Minutes of Pre-Bid Conference

PROJECT: WBS 33777.3.1 / DO00119 / B-4573 / Lincoln County Replacement of
Bridge No. 183

A mandatory pre-bid conference was held for the above listed project. A list of attendees is attached to these minutes. Mr. Zaki Wafa of the Bridge Management Unit conducted the pre-bid conference. The bid opening date is at 2:00 p.m., Thursday, March 31, 2011. The following items are noted and are hereby made part of the contract:

#183 + LINCOLN B-4573 + 33777

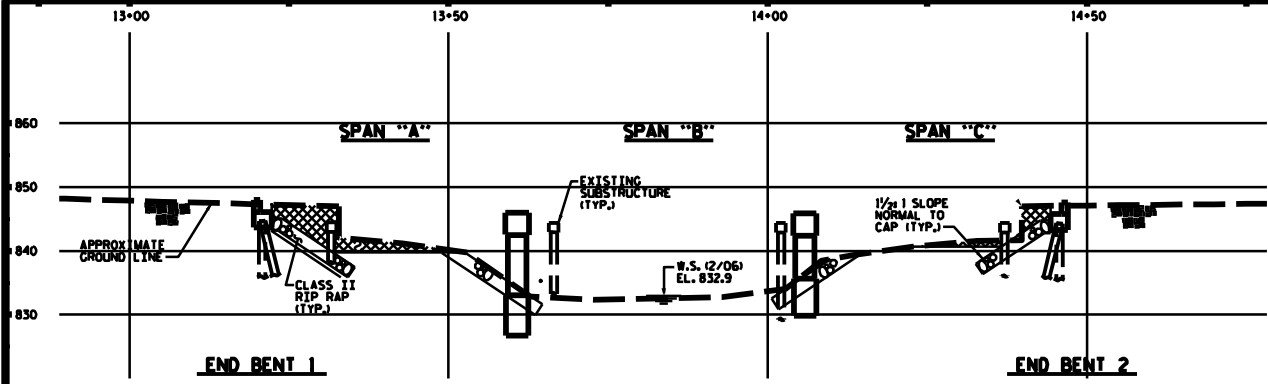
1. The USACE and DWQ have approved for Class II Rip Rap bank stabilization under the bridge. Rip Rap will be installed in such a way as not to obstruct the stream flow. Attached is the permit drawing showing the layout of the Rip Rap. The intent is to utilize a NW 13 (GC #3689) with no formal notification for the construction of the project.
2. Revised bid sheet page 179 dated 3-24-2011 changing the quantity of Class II Rip Rap to 487 Tons to count for the Rip Rap bank stabilization under the bridge.
3. Revised bid sheet page 180 dated 3-24-2011 correcting bid item 29 to read: "COIR FIBER BAFFLES" instead of "RESPONSE FOR EROSION CONTROL." The quantity is 65 LIN. FT.
